Product Change Notification / MFOL-05LHKQ810

CCB 5253 Final Notice: Qualification of MTAI as an additional final test site for MIC5219-5.0YMT-TR and MIC5219YMT-TR catalog part numbers (CPN) available in 6L UDFN (2x2x0.6mm) package.

CCB 5253
Pre and Post Change Summary
PCN #: MFOL-05LHKQ810

PCN #: MFOL-05LHKQ810

Pre and Post Change Summary – Pin 1 Orientation

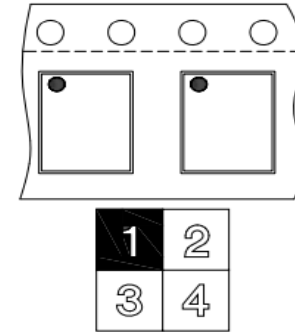
MTAI

Quadrant 1

Pre and Post Change Summary - Carrier Tape

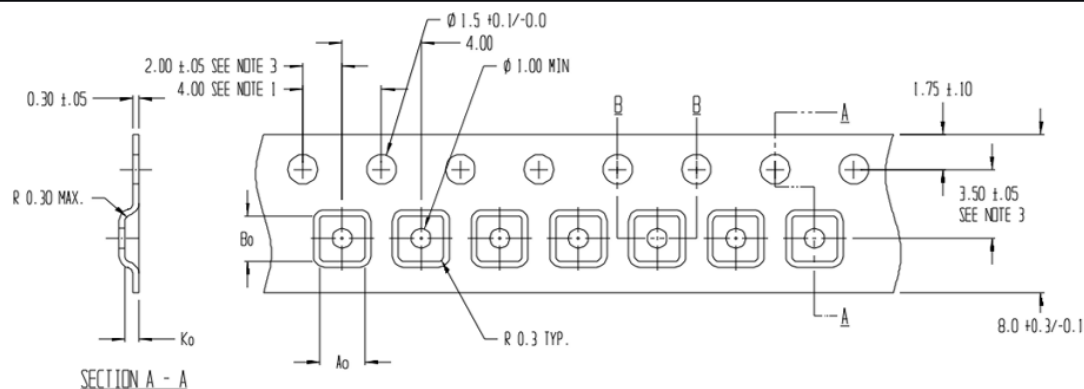
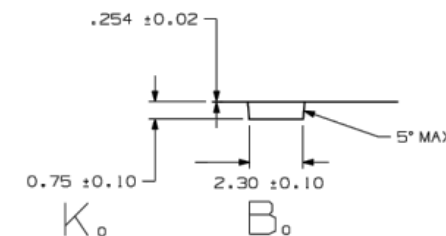
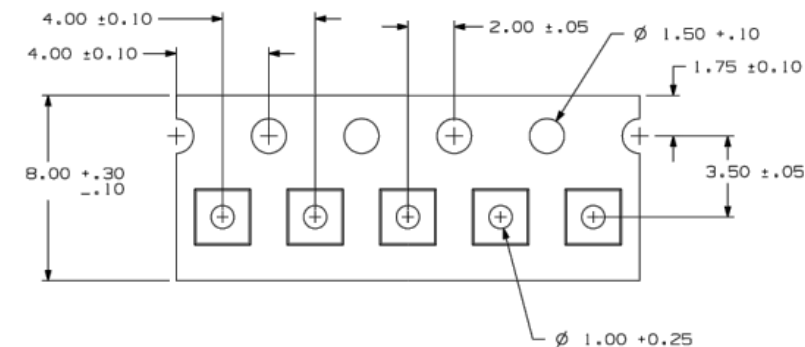
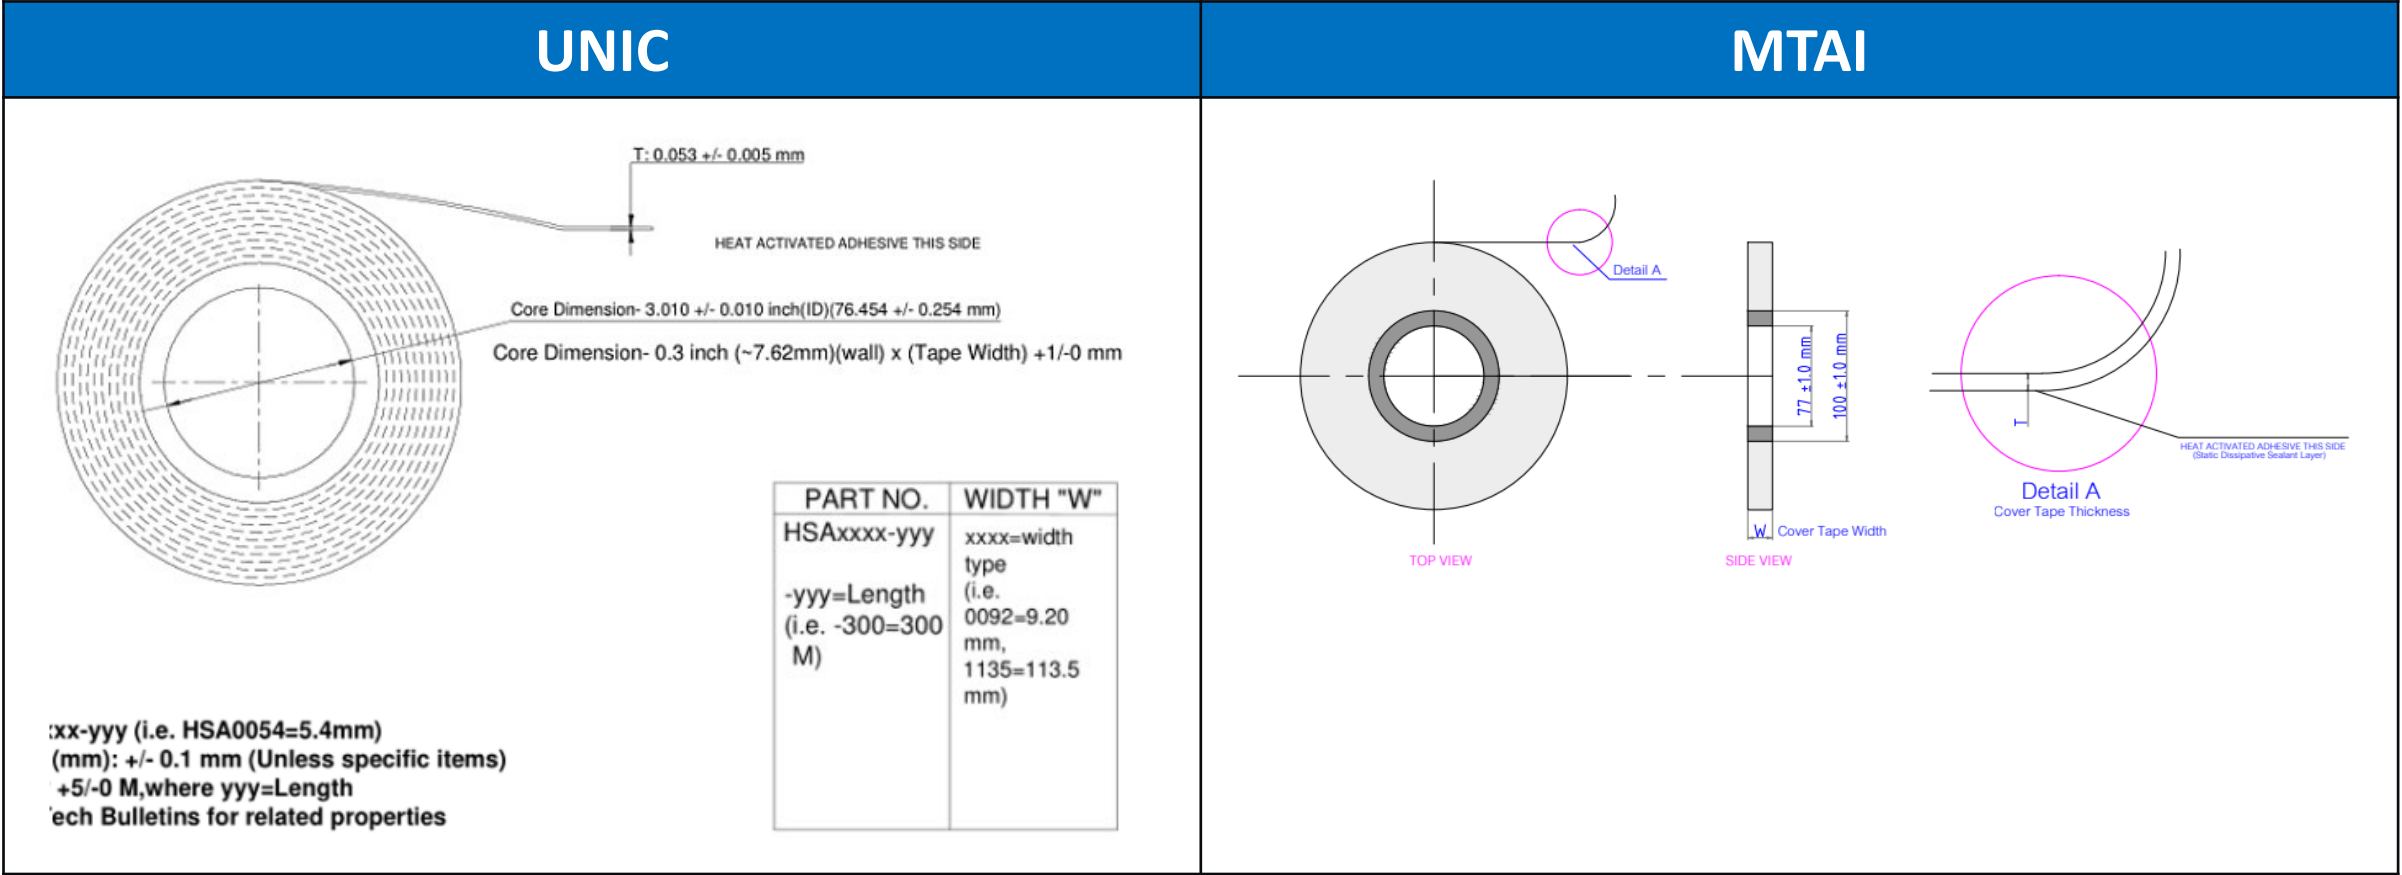
Plant	W (mm.) ± 0.3 or Specific	P (mm.) ± 0.1 or Specific	A ₀ ± 0.1 or Specific	B ₀ ± 0.1 or Specific	K ₀ ± 0.1 or Specific
UNIC	8.00+0.3/-0.1	4.00mm	2.30mm	2.30mm	0.70mm
MTAI	8.00+0.3/-0.1	4.00mm	2.30mm	2.30mm	0.75mm

Pre and Post Change Summary - Plastic Reel

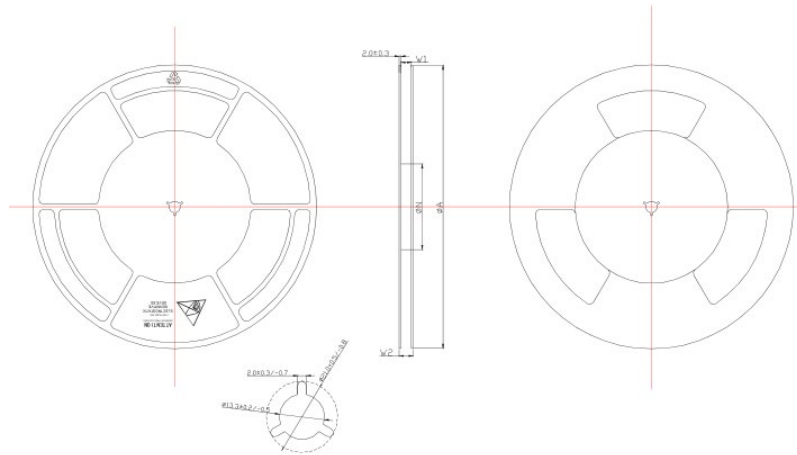
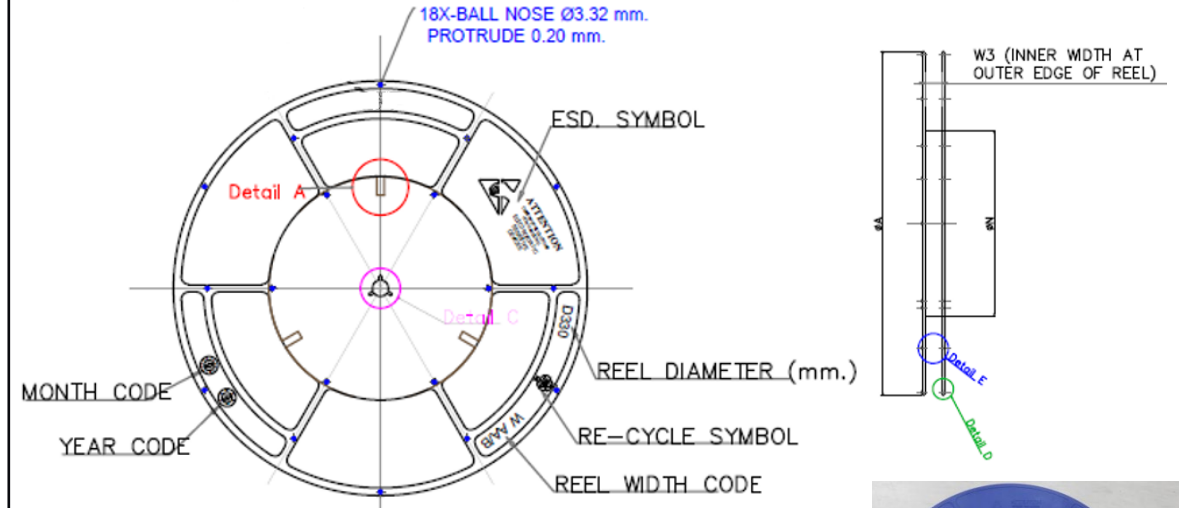
Plant	Reel diameter	Reel Hub Size (mm)	Reel Width Max (mm)	Reel Color
UNIC	330 +/- 2.0	178 +/- 1.0	15.4	White
MTAI	330 +/- 2.0	178 +0/- 2.0	14.40	Dark Blue

Pre and Post Change Summary – Static Shielding Bag

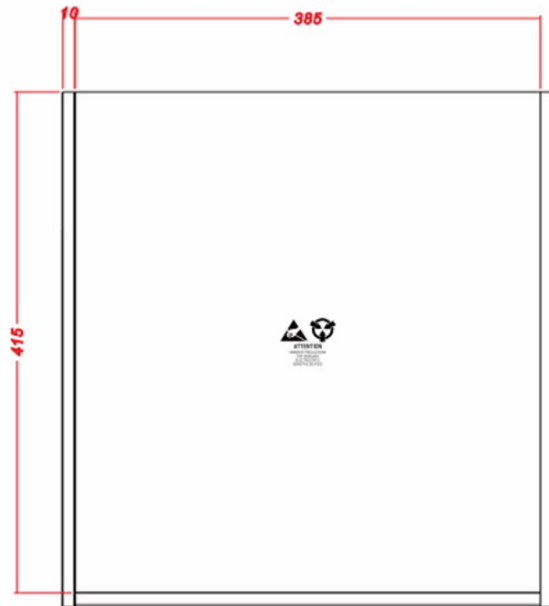
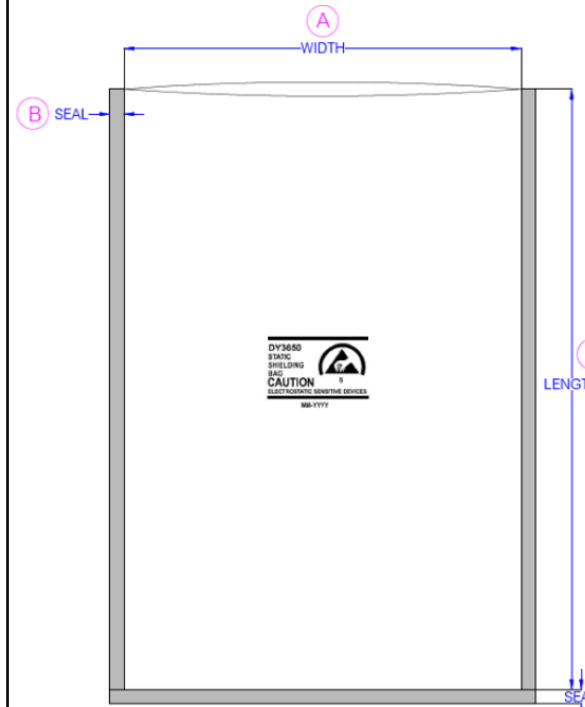
Plant	Length (mm)	Width (mm)	Thickness (mm)
UNIC	415	385	0.08
MTAI	420	370	0.076
